Chapter 4

H1: Steady, uniform flow in an open-ended channel

4.1 Problem Specification

Figure 4.9: H1 RMA-predicted conservation balances at $x = 3,000$ ft.

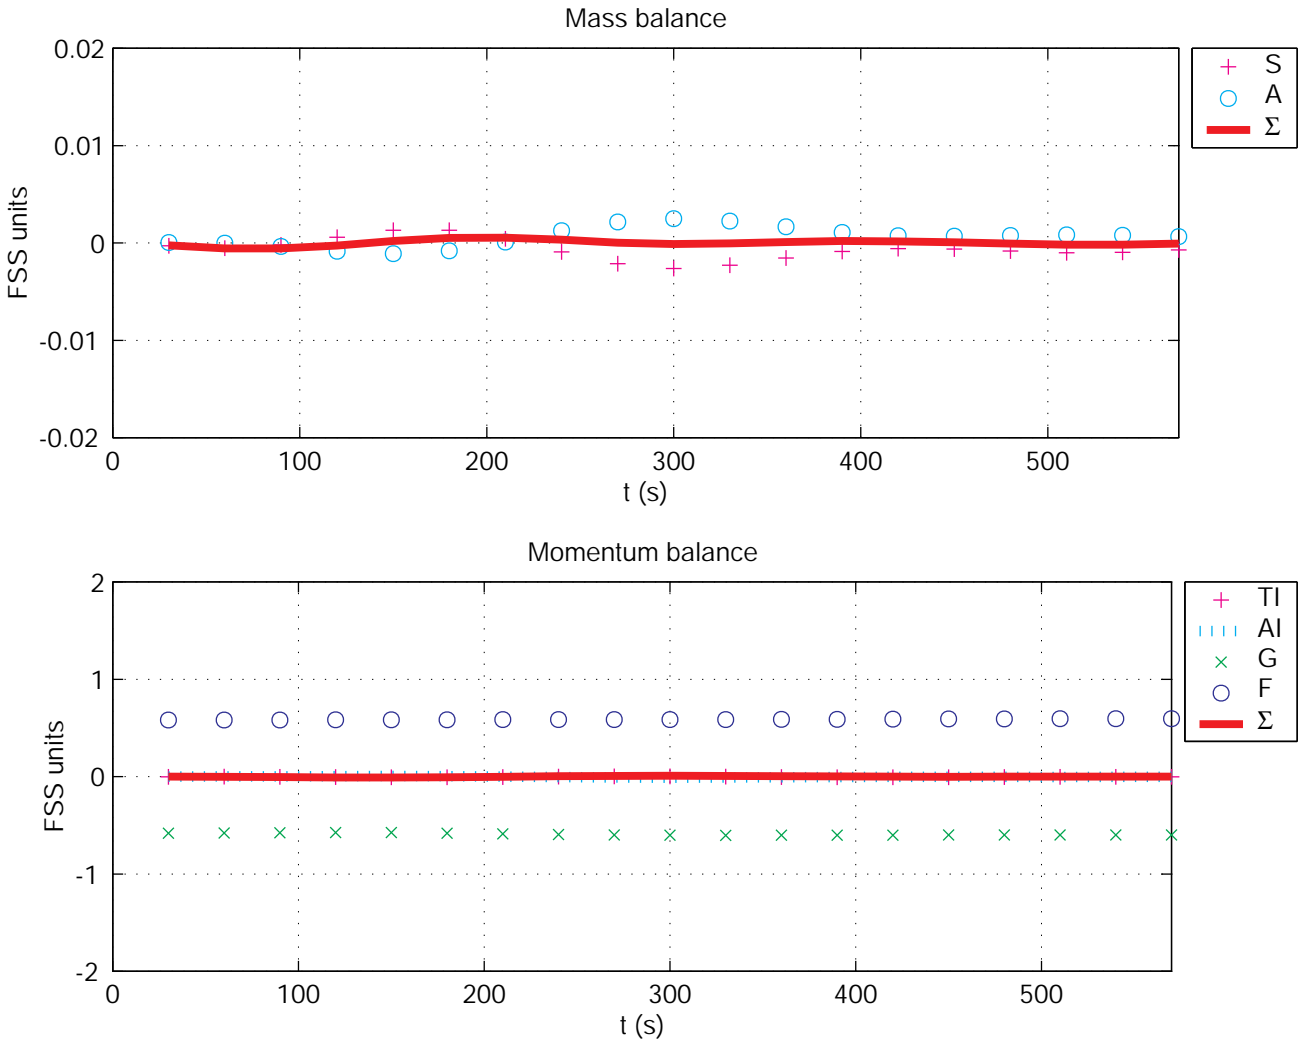
Figure 4.9 shows the time history of the mass and momentum balances at location $x = 3,000$ ft. The mass balance (the upper figure) shows each term in Equation 2.4.1; in the legend, S is storage, A is advection and $\Sigma = S + A$ is the mass balance, which should be identically zero. The model does not in fact conserve mass for $t < 300$ s. At these times, the solution evolution is dominated by the rapid initial transients that are poorly resolved by the adopted space scale ($\Delta x = 500$ ft) and time scale ($\Delta s = 30$ s). At later times, when the response is not resolution-challenged, mass is clearly conserved. This is the expected response.

The momentum balance (the lower figure) shows each term in Equation 2.4.2; in the legend, TI is temporal inertia, AI is advective inertia, G is gravity and F is friction. Again, $\Sigma = TI + AI - G - F$ is the momentum balance, which should be identically zero. There is only a hint of the initial transients here, and momentum is clearly conserved. Also shown is the dominant gravity = friction ($G = F$) balance for the steady, gradually-varied (almost uniform) flow.
